Project Name: Replace Roofs (Program Phase 1 - 4)

Title: Roof Replacement - Phase 1 Facility B

RFI#: 009

Location: Plan Set 22-090, FAC B UNIT 2

Plan(s) Sht/Detail: 22-090 Pg.A2.5, Keynote 13

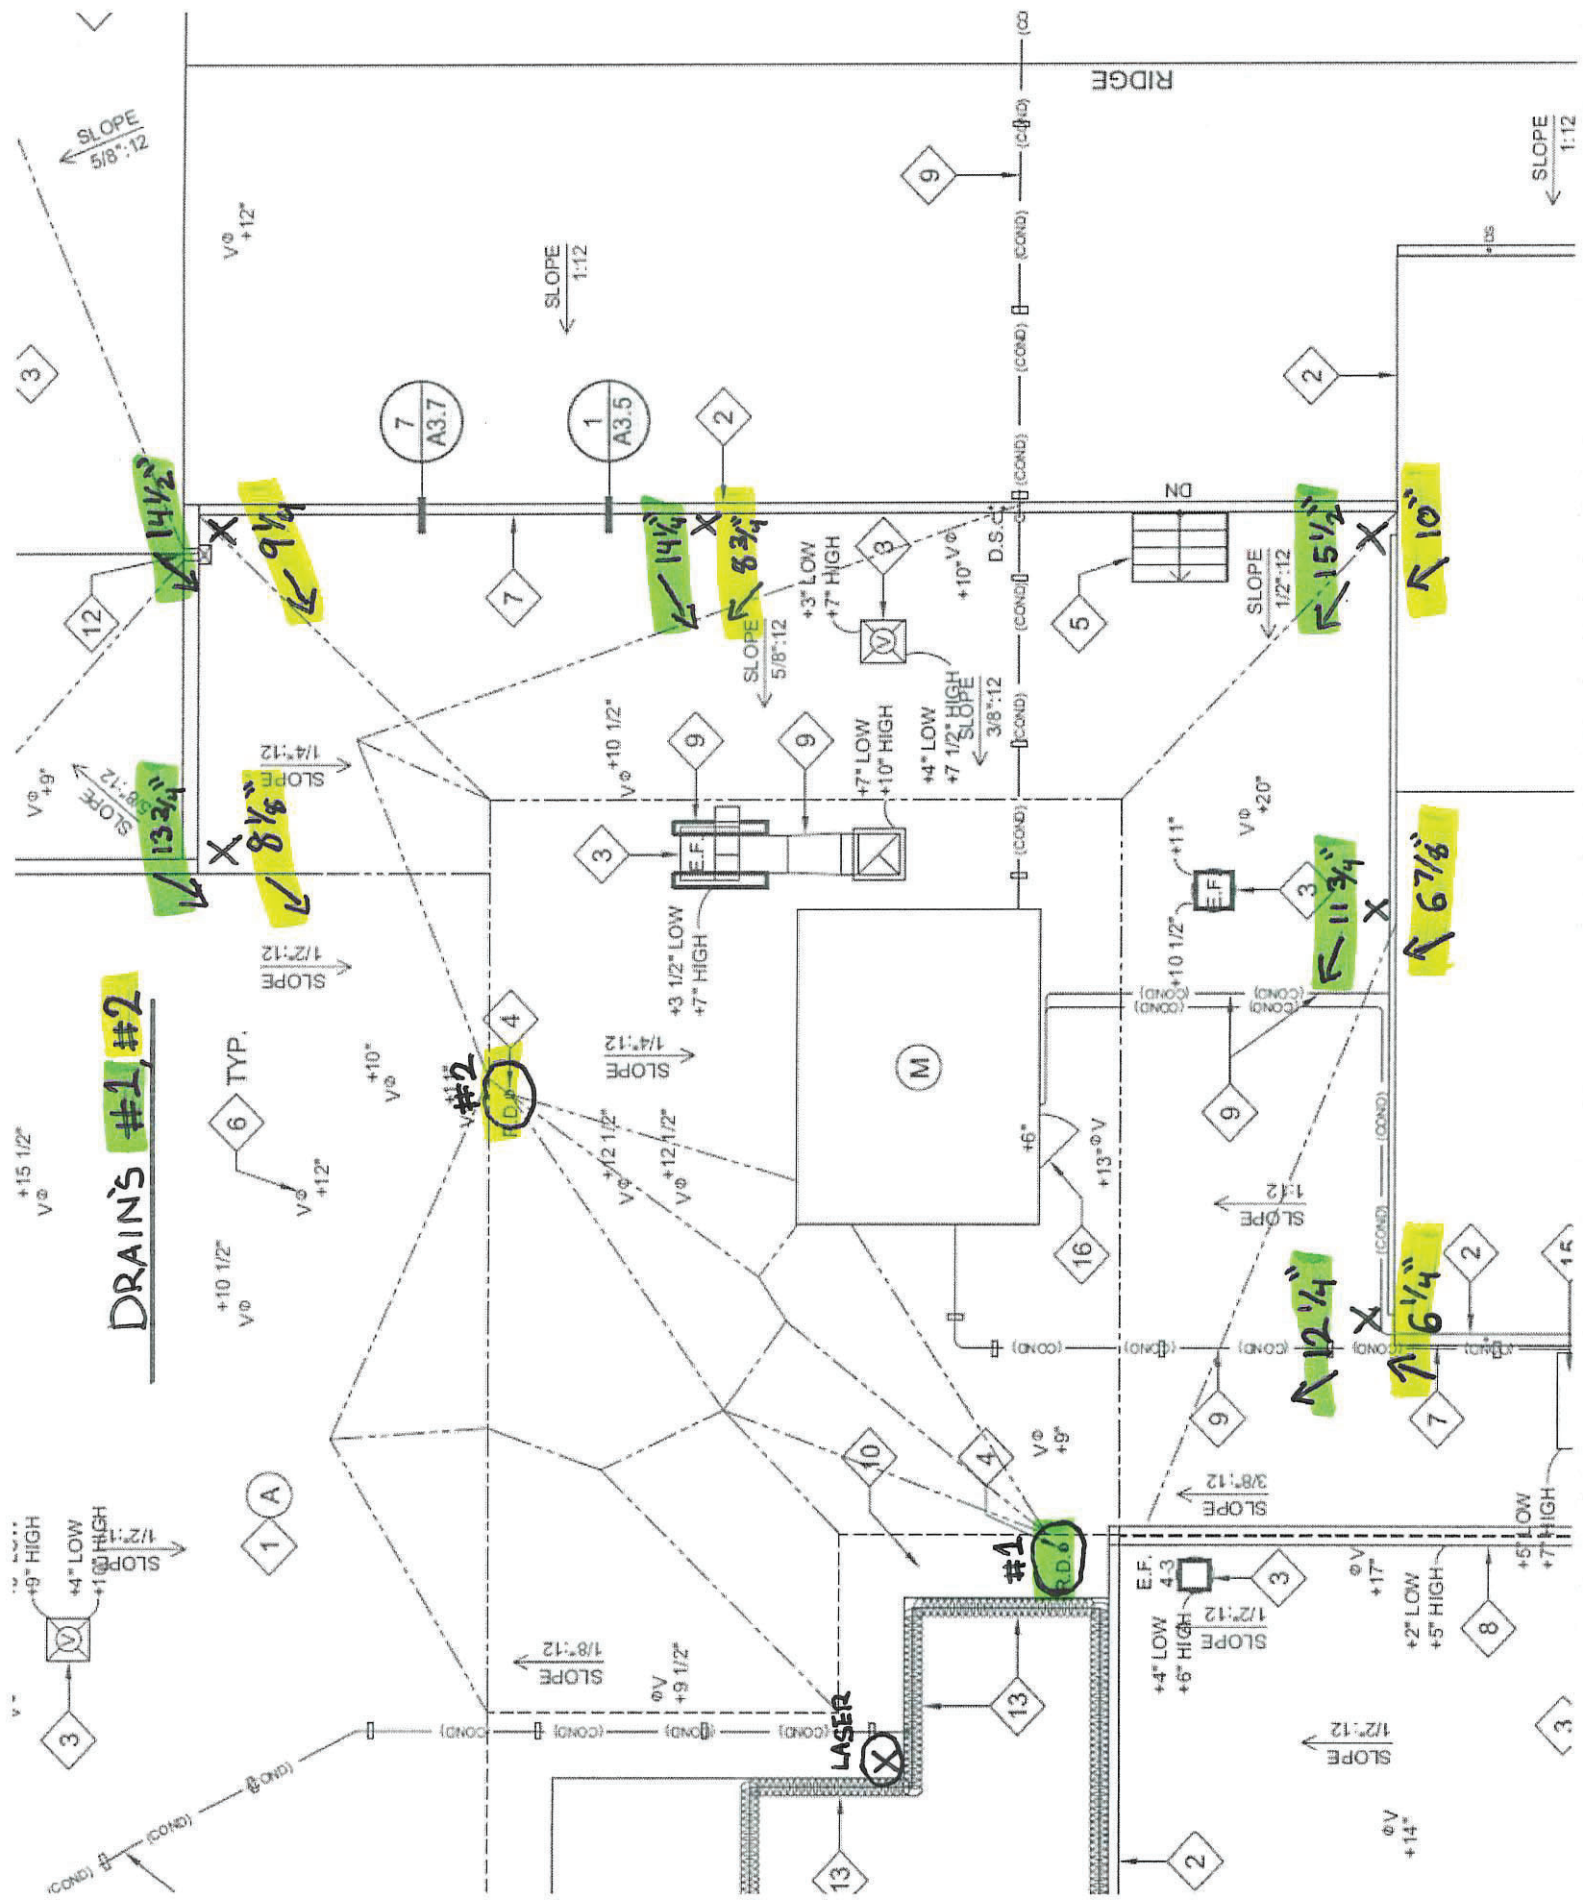
CCM request to verify attached Pg.A2.5 Keynote 13 highlighted and circled slopes are correct for Tapered Insulation Cricket. Multiple slopes on new work show sloping into Mechanical Rooms and away from drains. Please Advise. Field Staff Verified existing slopes to roof drains and flat area around Mechanical Room using a laser level. See Attached Drawings. Please verify slopes directions.

The slopes shown on the drawings need correction and are being corrected by the consultant. The new slopes will need to drain to the existing roof drains and the consultant will refine the drawings to indicate this. A CB with the corrected slopes/slope directions will be issued once this information is completed.
